# PERMIT

SEWAGE DISPOSAL SYSTEM

SUBDIVISION Lisbon Meadows

LOT 4, Blk. B, Sec. 2

INDICATE NORTH - NAME ADJOINING ROADWAY AS BASE LINE.

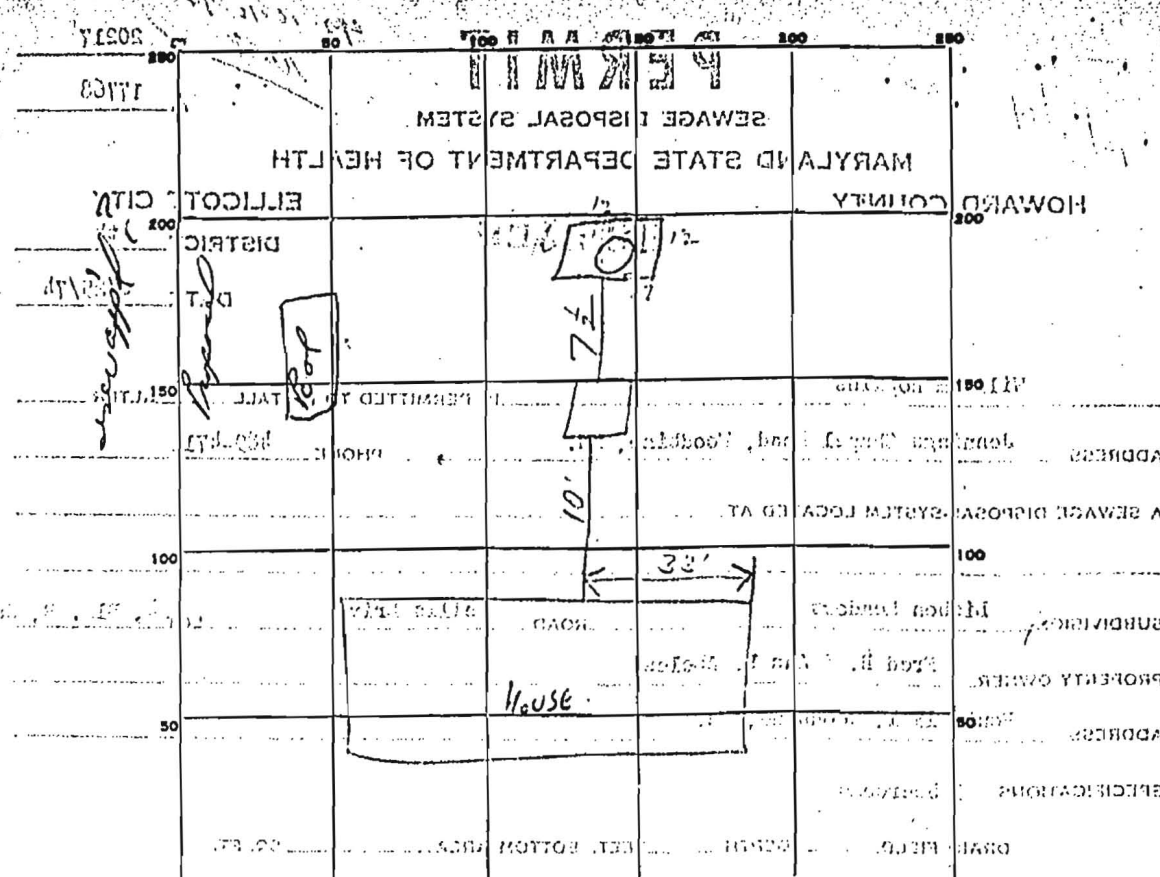
REMARKS Basement St. Cleanout Cap  
stop all work, py well in wrong location.  
60' off property line instead of 10' off left property line  
(4' short) HV - ovm 10/14/74  
10/14/74 placement septic tank cleanout cap HV
